**Proposal to amendments to ECE/TRANS/WP.29/2011/42  
(Revision of the Consolidated Resolution on the Construction of Vehicles (R.E.3))**

Note: The text reproduced below was adopted by GRSP at its 48th session on and proposes amendments to the proposal to develop amendments to Revision of the Consolidated Resolution on the Construction of Vehicles (R.E.3). This document is an update of ECE/TRANS/WP.29/2011/42, as reproduced in Annex V of ECE/TRANS/WP.29/GRSP/48. The modifications to ECE/TRANS/WP.29/2011/42 are marked in bold and strikethrough characters.

Annex 1, Appendix 1, Figure 2, amend to read:

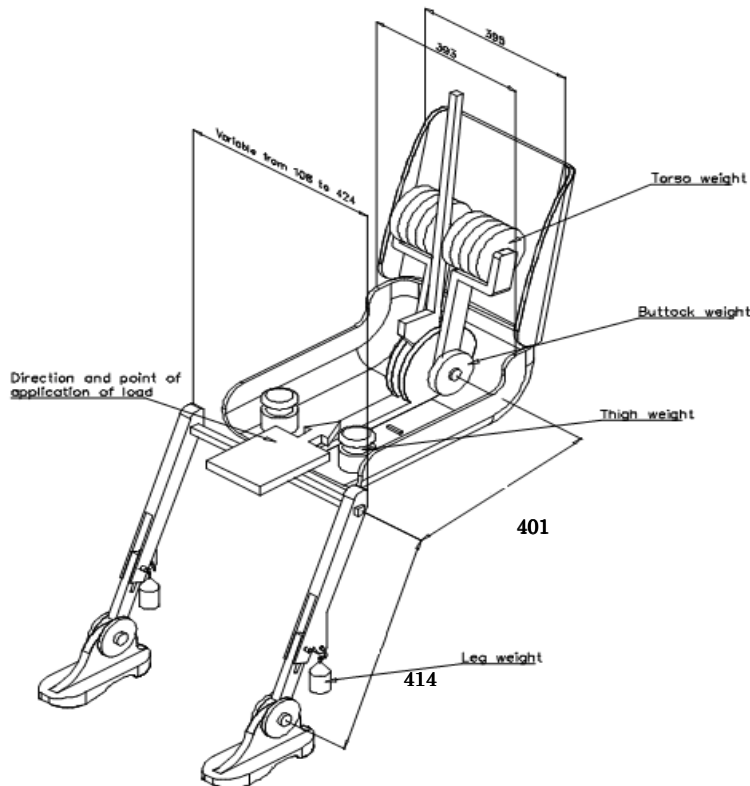
The expert from Japan at the December 2010 session of GRSP introduced GRSP-38-29 amending ECE/TRANS/WP.29/2010/145 (now ECE/TRANS/WP.29/2011/42). GRSP adopted it with further amendments concerning the dimensions of the 3-D H- machine elements (see ECE/TRANS/WP.29/GRSP/48 para. 48)
